Title		
Surearly Objet		
Size	Document Number	Rev
A3	LCD & BLE	1.0
Date:	Wednesday, July 08, 2026	Sheet 1 of 6

- PCB design changes

- MAIN : ADD RTC I2C Net (bug fix)
- OPTIC : ADD Filter, change opamp power
- USB PCB : bug fix, remove switch
- ADD Switch PCB

Title		
Surearly Objet		
Size	Document Number	Rev
A3	USB PCB	1.0
Date:	Monday, July 20, 2026	Sheet 6 of 6

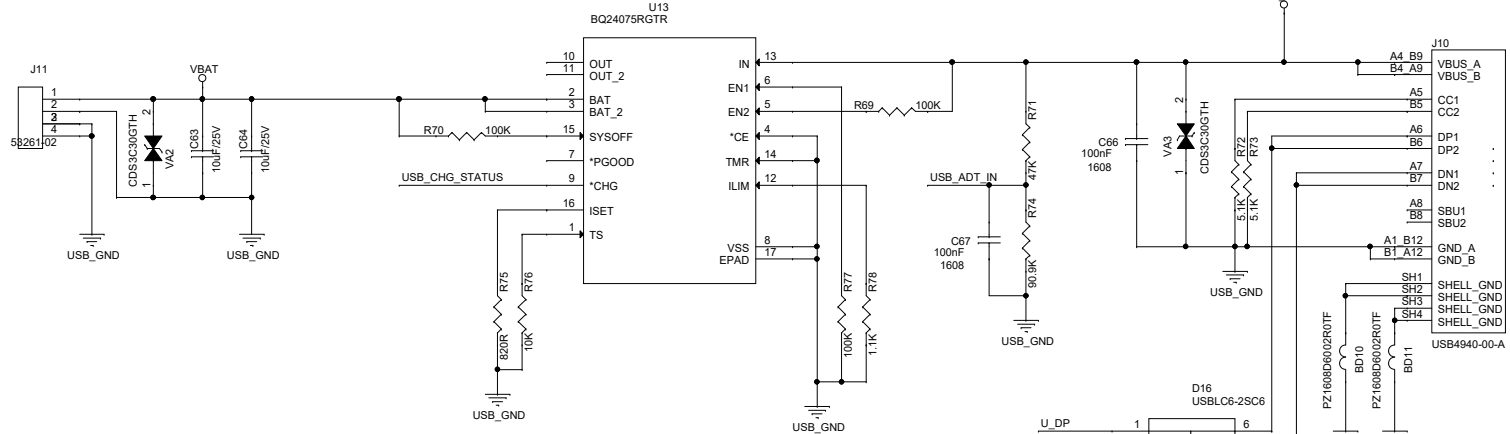
USB 전원 입력 시 POWER ON 방법 변경

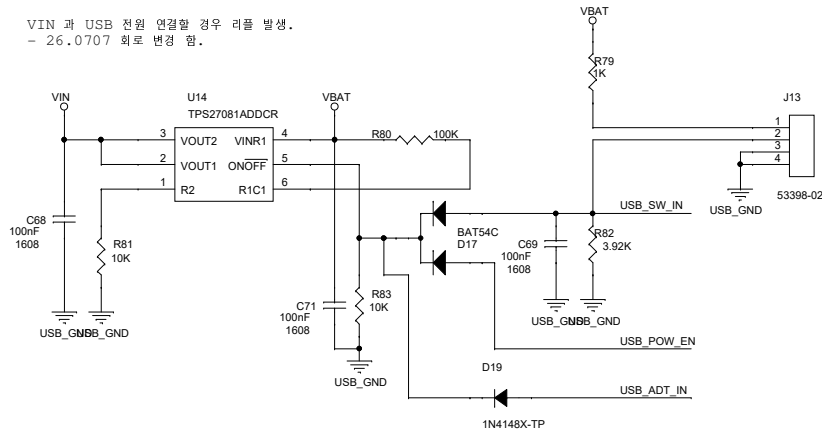
VIN 과 USB 전원 연결할 경우 리플 발생.
- 26.0707 회로 변경 함.

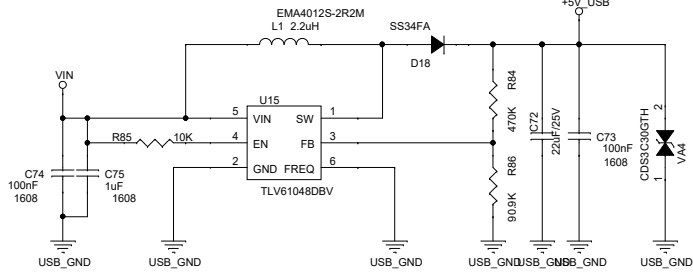
파트 변경 - 기존 파트 잘못되어 수정
(삽입 방향 잘못됨 - PCB Decal은 수정 필요 없음)

Size 및 값 변경
